RCA-72-22-001-1: Passenger Airbag Harness Pinch Condition

Document Type	Customer Satisfaction Campaign Bulletin
Date	January 13, 2022
Affected Region(s)	USA
Affected Model(s)	R1T
Model Year(s)	2022
Approximate Build Dates Refer to the FSA Dashboard to determine if this document applies to a specific vehicle.	August 2021 - September 2021
Vehicle System	72 - Occupant Protection
Minimum Service Location	Mobile

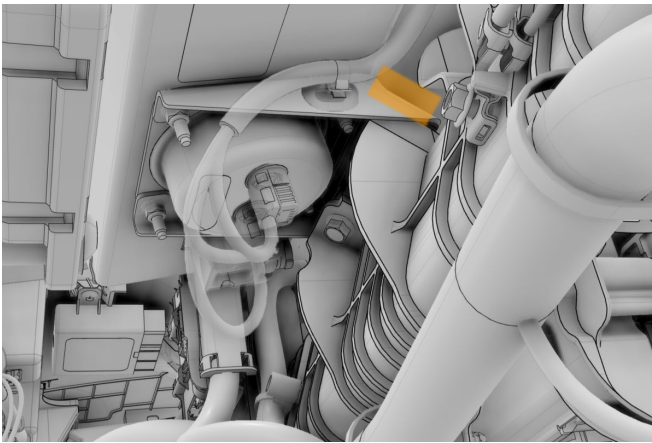
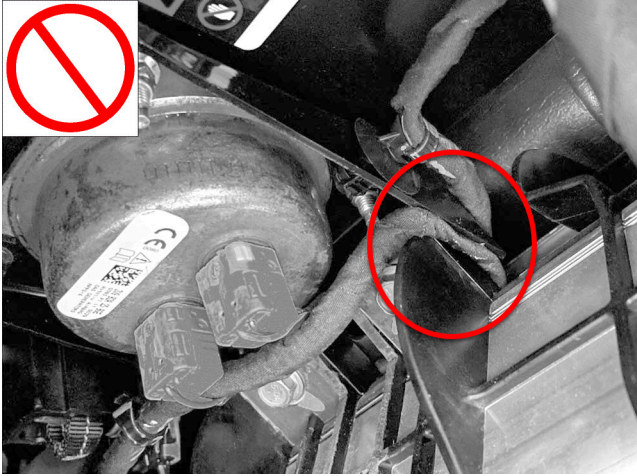
Rivian is initiating a customer satisfaction campaign for some model year 2022 R1T vehicles that may have been built with a pinch condition of the passenger airbag wire harness in the instrument panel. If the wires are damaged the airbag light will illuminate, indicating a fault in the system. Rivian is launching this campaign for customer satisfaction and for the continuous improvement of Rivian vehicles.

1. Remove: Cover, Instrument Panel, Lower (refer to service manual procedure 641030010).

2. Make sure that no harnesses are routed forward of the airbag bracket. If necessary, route any harnesses out of the highlighted area.

3. Reinstall all components that were removed for access.
